ADDENDUM #1
ITB NO. 1005-0-2019, MARTIN COUNTY HIGH SCHOOL (MCHS)
BUILDING REPAIRS PROJECT

DATE: 09/13/19

MARTIN COUNTY HIGH SCHOOL EXTERIOR STUCCO REPAIRS & GUTTER/DOWNSPOUT REPLACEMENT: CAFETERIA & MUSIC BUILDINGS

1 NORTH ELEVATION - MUSIC
SCALE: 1/8" = 1'-0"

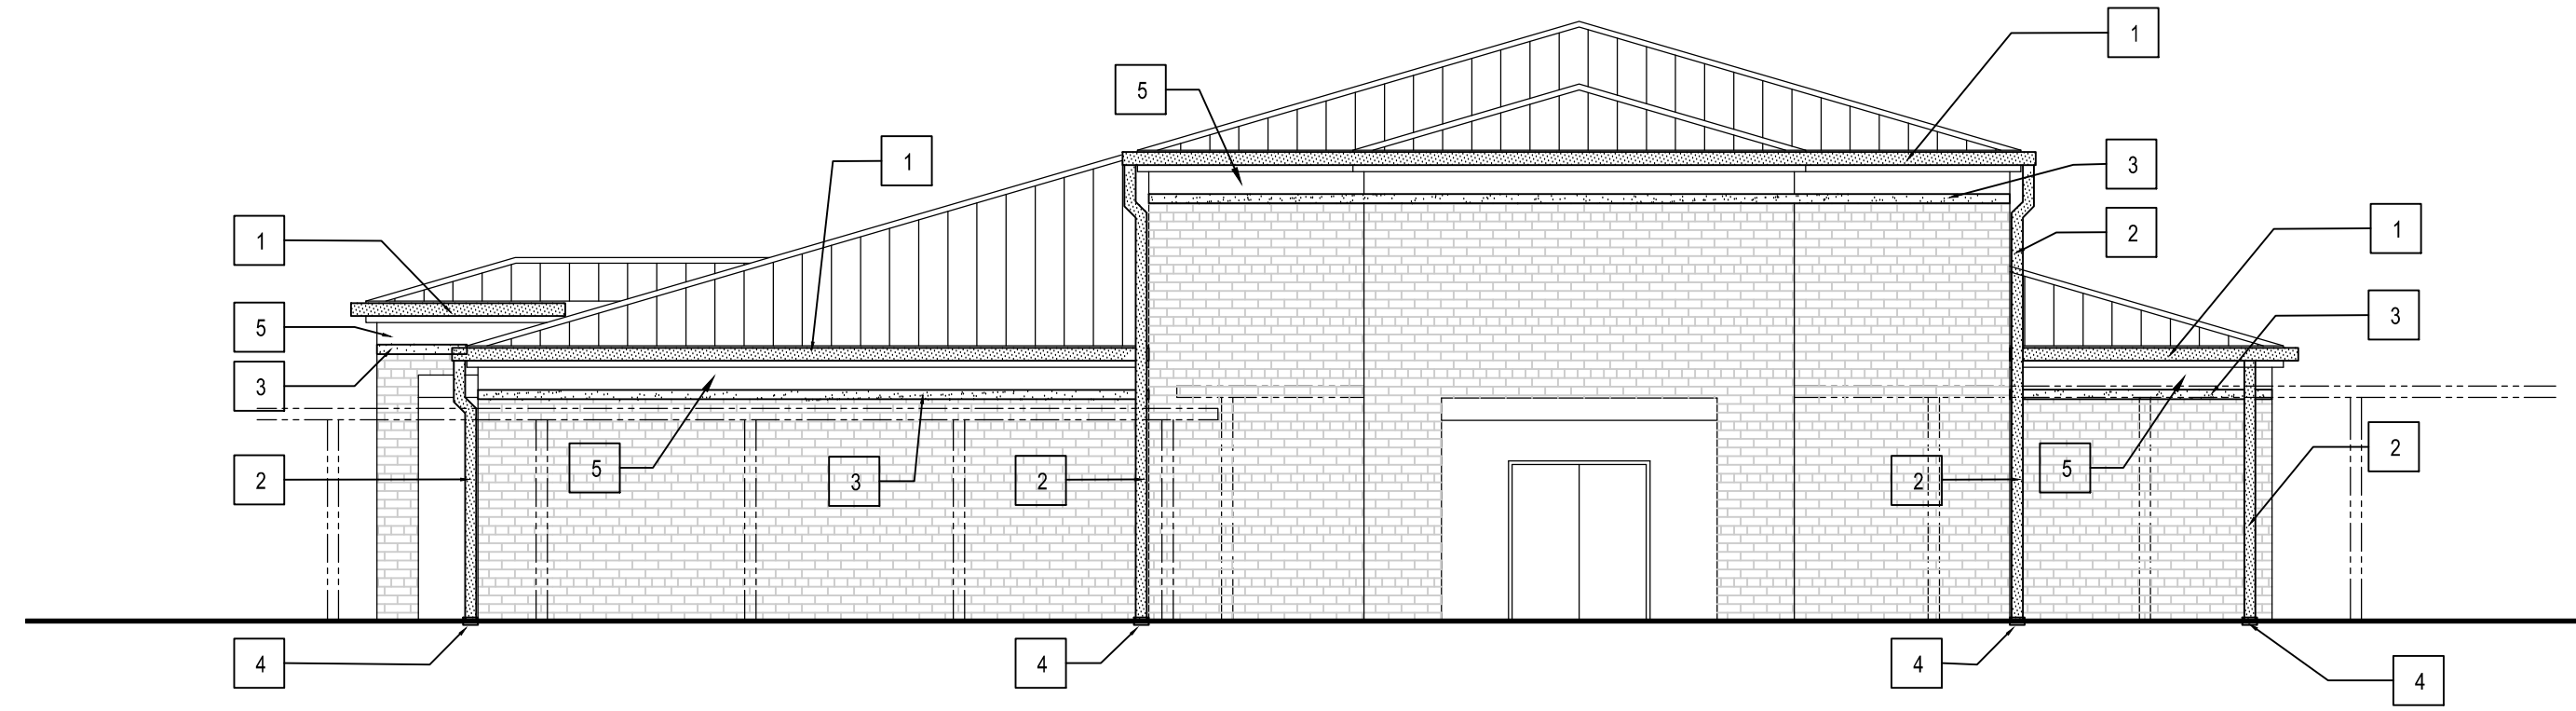
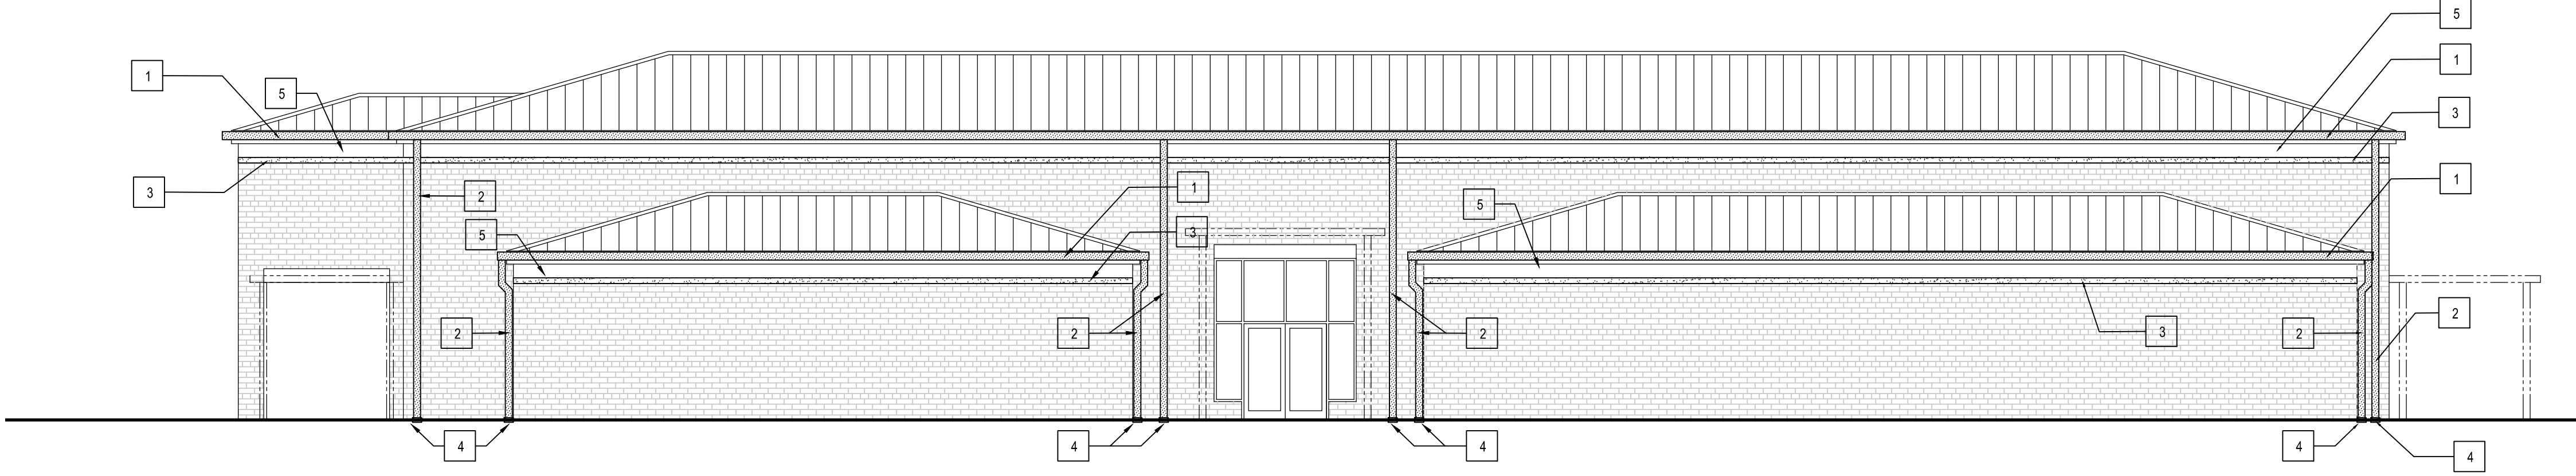
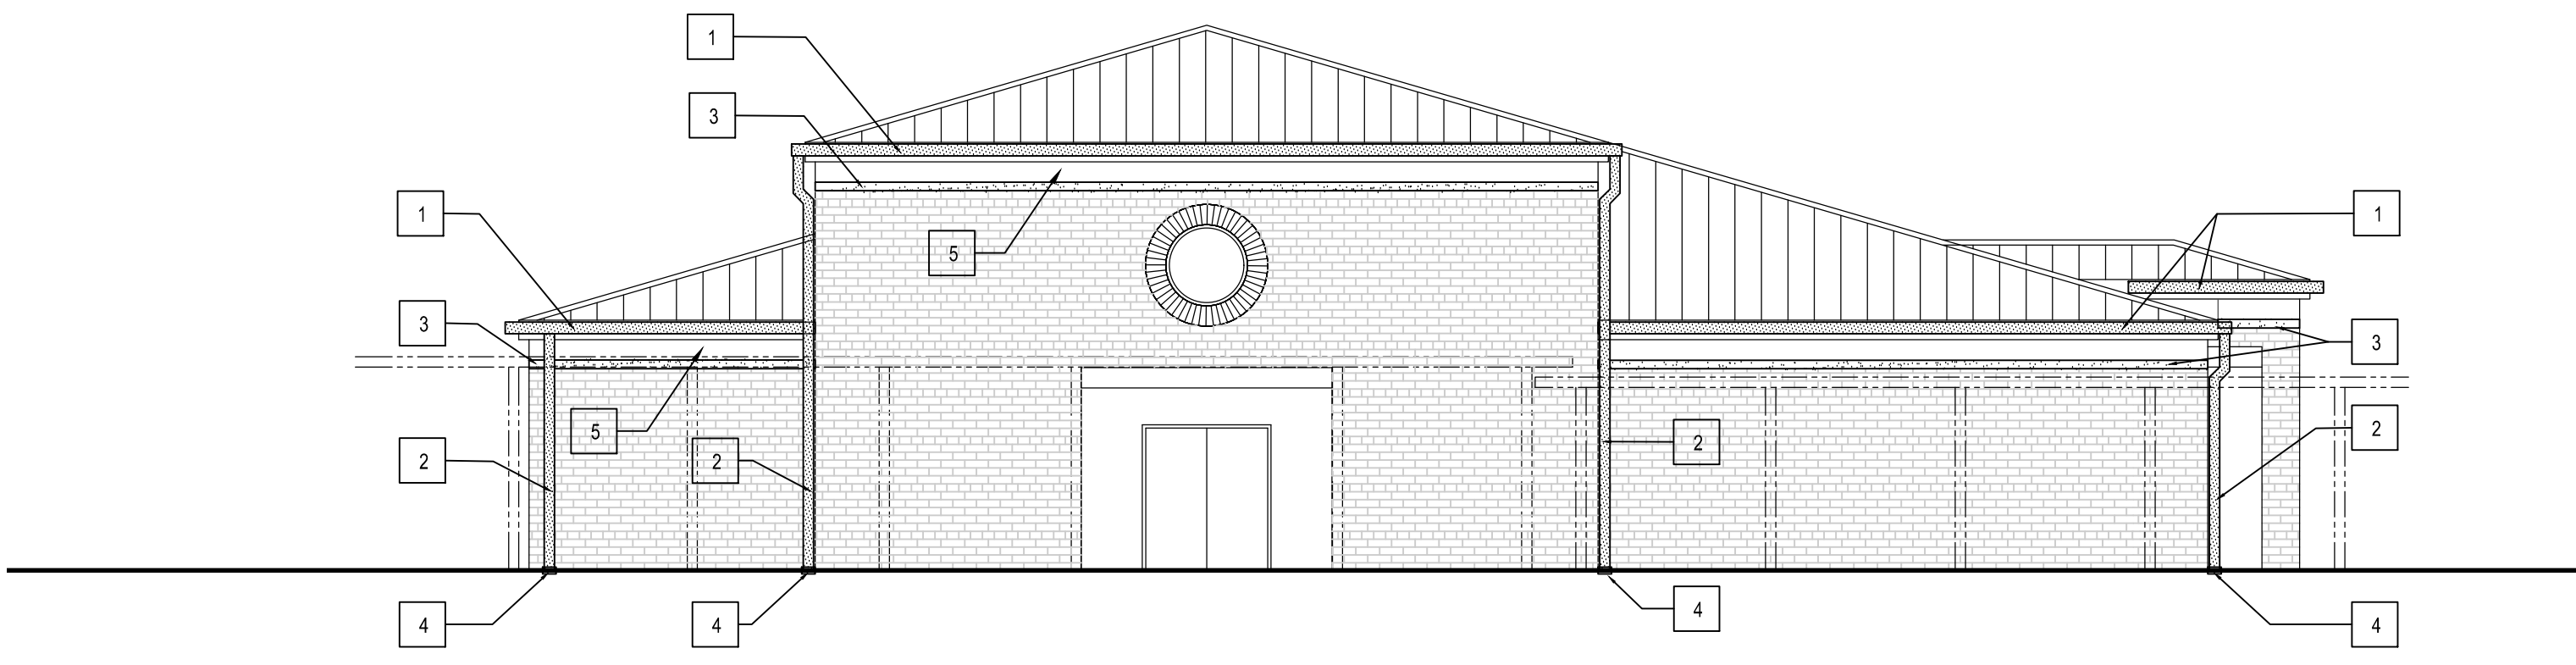
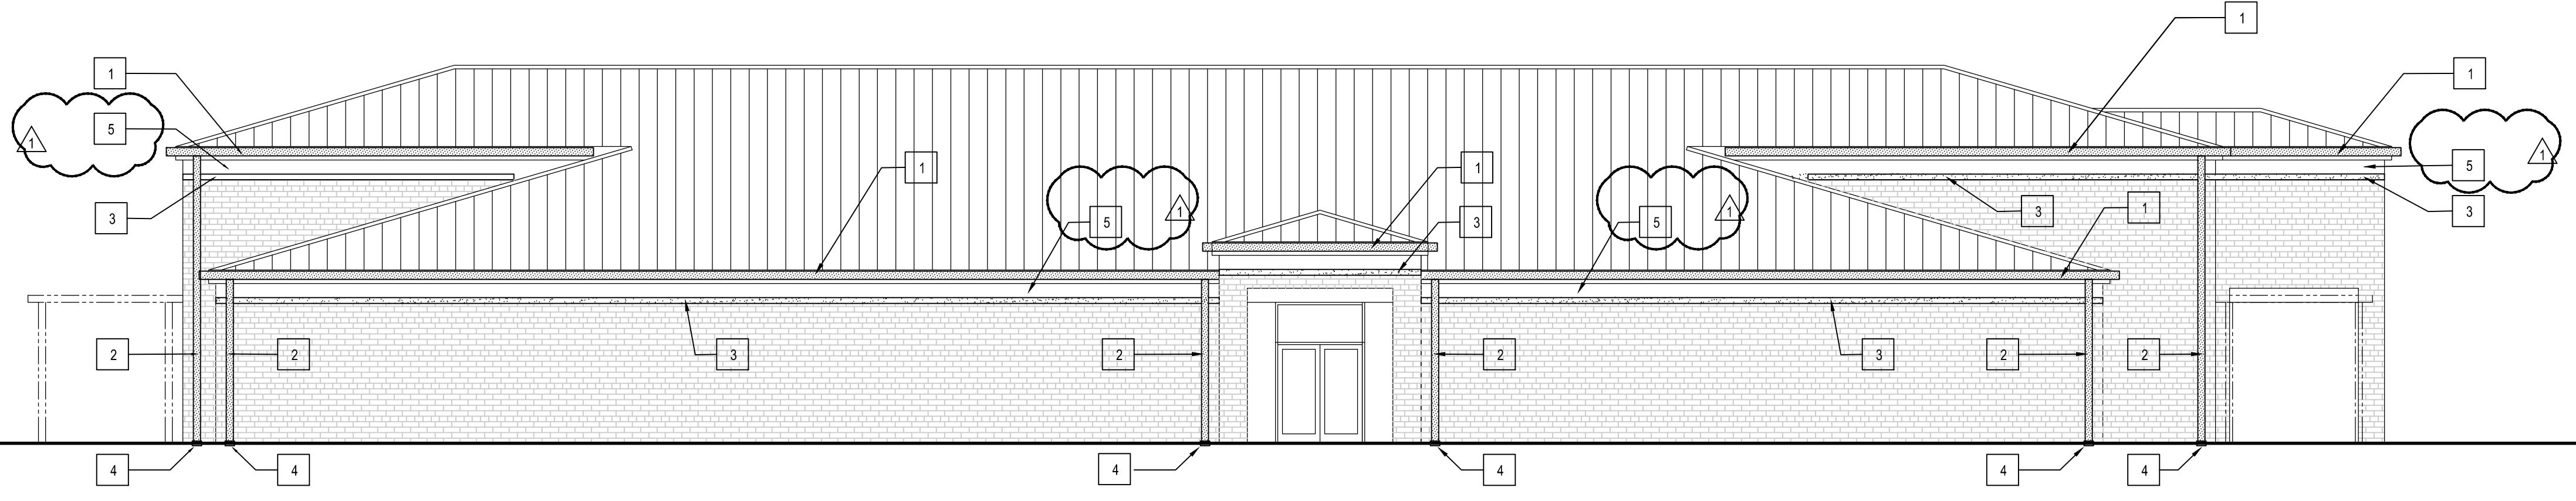
Answer: No, Subcontractor Participation Requirement cannot be waived.
2. **Question: Vertical Stucco Surfaces** - Drawings show painting of horizontal stucco surfaces only (Ref: Note # 5). During the site visit, we noticed. Please confirm that existing vertical stucco surfaces would also get painted to match?

Answer: Yes, paint the vertical stucco areas to match the horizontal stucco areas.
3. **Question: Note #5 Cafeteria** - Note # 5 is not referenced in Cafeteria Elevations. Please advise.
